STAFF REPORT

SUBJECT: Pollard Subdivision - TECC
[TECC-2023-0001](#)

I. PROJECT DESCRIPTION

Request for a one-year time extension on the preliminary plat in order to obtain the City Engineer's signature on the final plat.

A. Preliminary Plat (date: 1/10/2019) & Phasing Plan

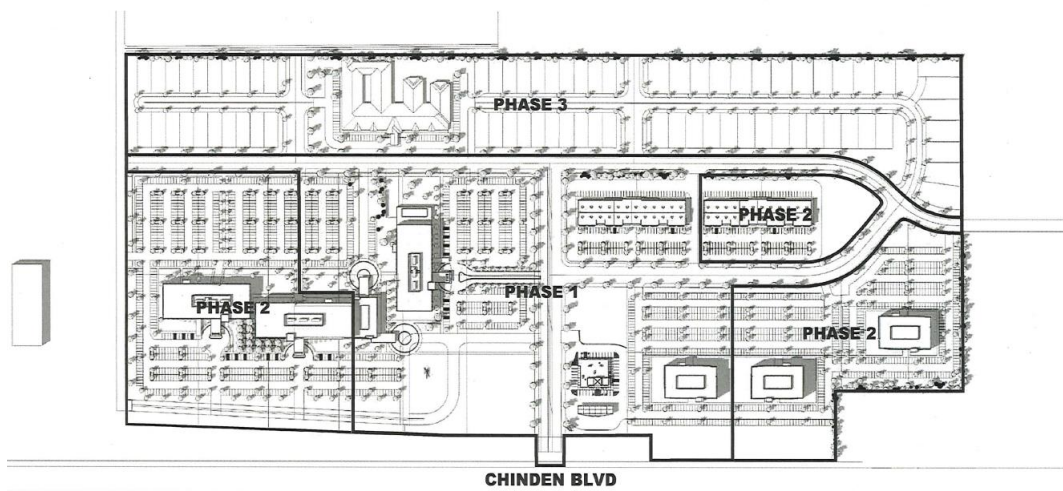
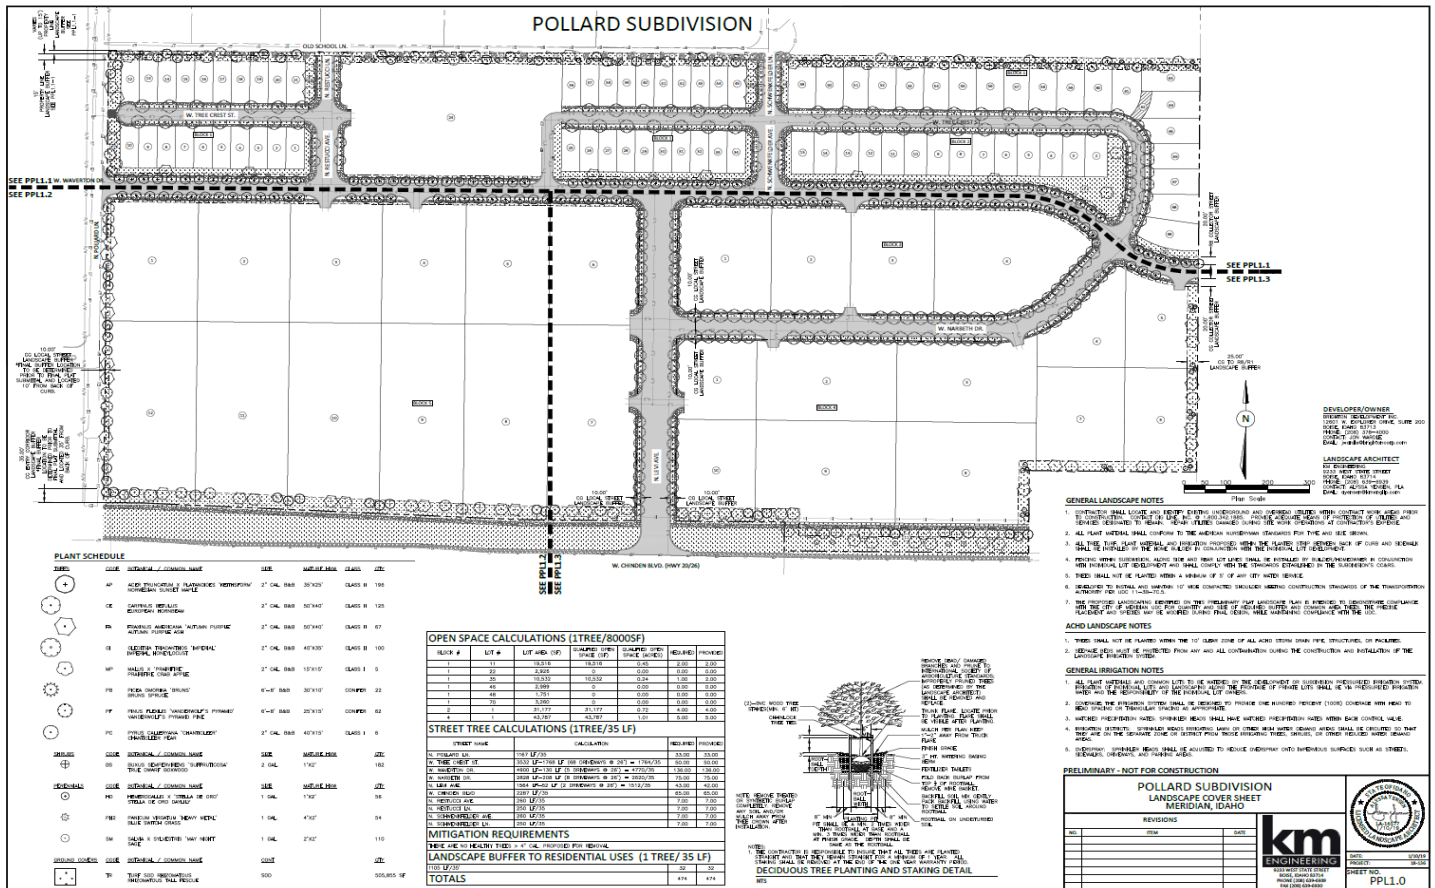
- The amount of qualified open space for the R-8 zoning district has increased from 10% to 15% and some of the standards for such have been modified. See UDC [11-3G-3](#) for more information. *A total of 2.19-acres (or 12.19%) was proposed for the 17.97-acre area. Based on the current standard, a minimum of 2.7 acres would be required, which requires an additional 0.51-acre of qualified open space.*

- The number of site amenities for residential developments have changed from one amenity for each 20 acres of development area to a point system requiring one (1) point of site amenity for each 5-acres of land. See UDC [11-3G-4](#) for more information. *One (1) amenity, a children's play structure, was proposed with the preliminary plat. Based on the current standard, a minimum of 4 points of site amenity would be required; a tot lot qualifies as one (1) point – additional amenities totaling at least three (3) points are required to comply with the current standard.*

4. The plans submitted with the final plat application for the residential portion of the development shall be revised to comply with the following:
 - a. Comply with the qualified open space standards for the R-8 zoning district listed in UDC [11-3G-3](#). *A minimum of 2.7-acres of qualified open space is required.*

- b. Comply with the qualified site amenity standards for the R-8 zoning district listed in UDC [11-3G-4](#). *A minimum of four (4) points of site amenity is required.*

B. Approved Landscape Plan (dated: 1/10/2019)

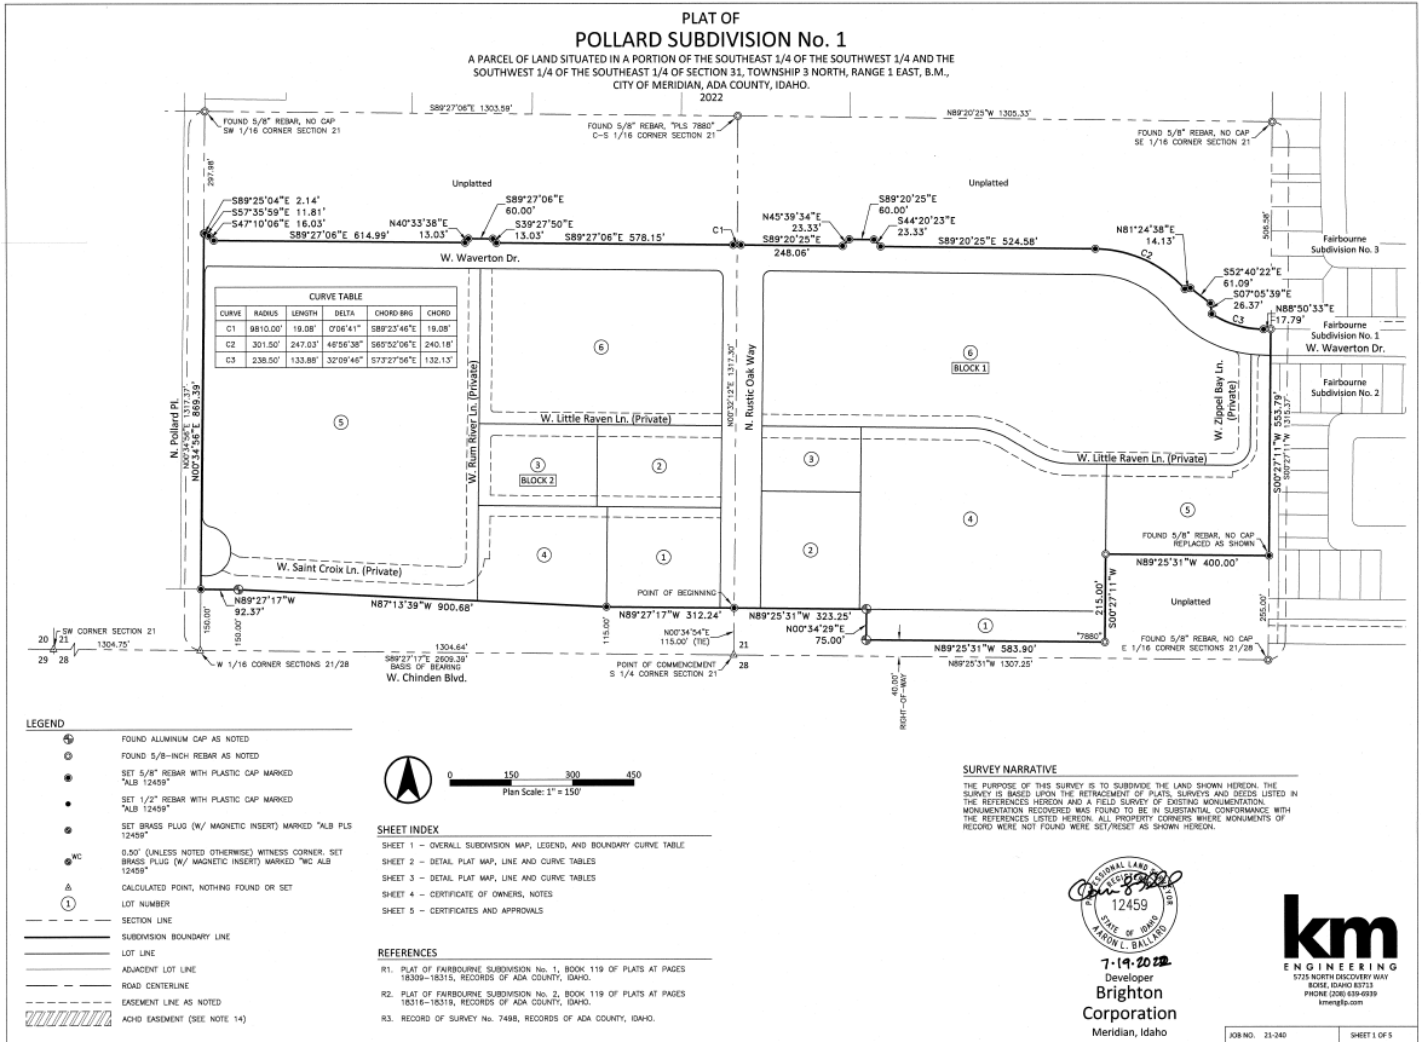
Staff further recommends the landscape plan for the first phase final plat approved by City Council but not yet recorded, be amended through an administrative landscape plan modification application to reflect compliance with the updated landscape standards for street buffers. *Note: If a hospital develops in the commercial portion of the development as originally anticipated, a conditional use permit will be required for approval of the use. As a condition of approval, compliance with the traffic noise abatement standards listed in UDC [11-3H-4](#) will be required; or, alternative compliance may be requested where the Applicant has a substitute noise abatement proposal in accord with ITD standards and prepared by a qualified sound engineer.*

2. Comply with the off-street parking standards listed in UDC [Table 11-3C-6](#) for single-family residential dwellings.
3. Prior to submittal of the Pollard Subdivision No. 1 final plat (FP-2022-0023) for City Engineer signature, submit an administrative landscape plan modification application to revise the landscape plan to reflect compliance with the updated standards listed in UDC [11-3B-7C](#) for street buffers, including those for entryway corridors (i.e. W. Chinden Blvd.SH 20-26).
